Addendum / Addenda

Project Description / Description de projet		
Smart Building Monitoring and On-going Commissioning - Maritime Provinces		
Solicitation No./N° de sollicitation	Project No./N° de projet	W.O. No./N° d'ordre de travail
19-58046		
Departmental Representative / représentant ministériel		Date
Scott Shillinglaw		November 8, 2019
<p>Notice:</p> <p>This addendum shall form part of the tender documents and all conditions shall apply and be read in conjunction with the original plans and specifications.</p>		<p>Nota:</p> <p>Cet addenda fait partie intégrale des dossiers d'appel; toutes les conditions énoncées doivent être lues et appliquées en conjonction avec les plans et les devis originaux.</p>

RFP 19-58046 – Smart Building Monitoring and On-going Commissioning –
Maritime Provinces

Questions and Answers – Part II

- b. Air-Gap Switching System Diagram:

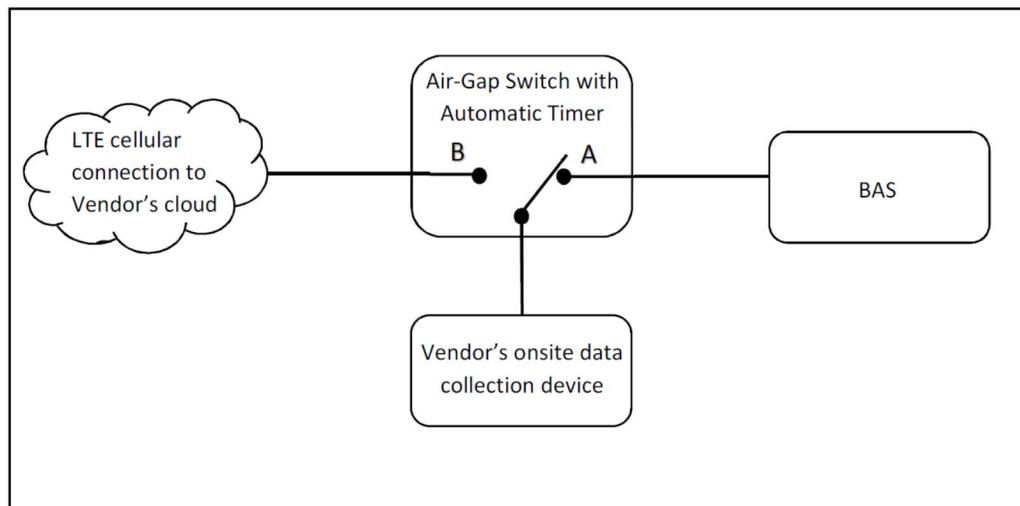
2. In Section 2.13.1, paragraph G of Appendix A “Statement of Requirements” of the RFP, you say that the bidder’s cyber-security design must include “a mechanically operated isolation system”... Would it be possible to provide more details about that requirement?

- F. Communications protocols must be secured (ie, use of SSL)
- ② G. The Bidder's cybersecurity design must include an air-gap switching system to ensure the Contractor's onsite hardware is never connected to the BAS at the same time it is connected to the Contractor's cloud server.

- a. Air-Gap Switching System Requirements:
 Layer-1 A/B network switch specifically designed to switch a device connection between two networks, with support for CAT6 up to 10 Gbps Ethernet. The relay mechanism must be mechanically actuated and operate at the physical layer, meaning the two ports A/B are always physically isolated. Network switching must be done through a timer device (integrated or external to the air-gap switching system) to allow periodic data transfer to the Contractor's cloud server.

Answer: Refer to addendum #2.
